# Arborist Report

## 3150/3152 Somerset Street, Victoria

Date submitted: January 08, 2021.  
March 25, 2021 Amended.  
June 03, 2021 Amended

1 Site Plan - Proposed  
Scale: 1:100

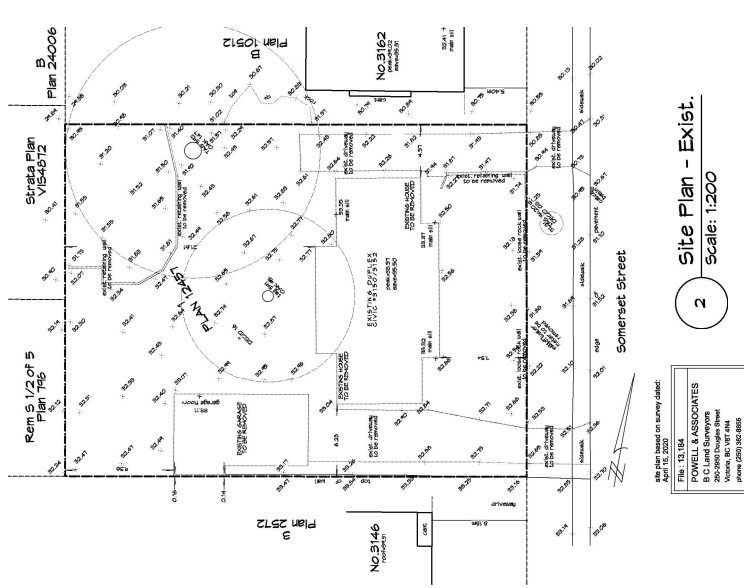
Lot A – Both bylaw -protected Garry oak trees on the property #591 and #592 are located within the boundaries of proposed lot A and the linden tree is also located on the municipal frontage of this lot.

- Little Leaf linden #9420 – This tree is located where it will be detrimentally impacted by the construction and access to the front of the lots and is proposed to be removed. Three replacement trees are proposed to be planted along the municipal frontage of both lots.

- Garry oak #591 – This tree is located within the side-yard setback of proposed Lot A but where it would also be impacted by the footprint location on Lot B. The removal of this tree would be required to accommodate construction on the two lots, however, due to the extensive decay within the lower trunk and root collar its removal would already be required.

- Garry oak #592 – This tree is located within the defined building envelope on this property, but outside the proposed building footprint. The footprint will encroach well into the defined critical root zone area but only in one quadrant of this root zone. The area of encroachment has been filled historically with fill soil that appeared to be up to 1 metre in depth.

**Barrier Fencing** The areas surrounding the tree to be retained must be isolated from the construction activity by erecting protective barrier fencing. Typically, the fencing is erected at the perimeter of the critical root zones as defined in our Tree Resource Spreadsheet or at the edge of the canopy spread. On this site, the building footprint extends into the critical root zone area of Garry oak #592 as defined therefore the fencing is to be erected 1 metre off the edge of the building footprint in the area of encroachment and out to the edge of the critical root zone outside this area of encroachment. Barrier fencing should also be erected along the north edge of the driveway footprint where it crosses the municipal frontage to protect the canopy overhang from the adjacent municipal maple tree.

- Around the canopy spread of the municipal linden tree.
- Across the back of the existing building footprint, approximately 2 metres outside this footprint of the existing building to isolate the critical root zones of the protected trees from machine access and encroachment. If the removal of Garry oak #591 has not been approved and the tree removed prior to the time of demolition, fencing must be erected to protect the root zones of both oak trees.
- The project arborist must supervise the excavation to remove the existing footings adjacent to oak #591.
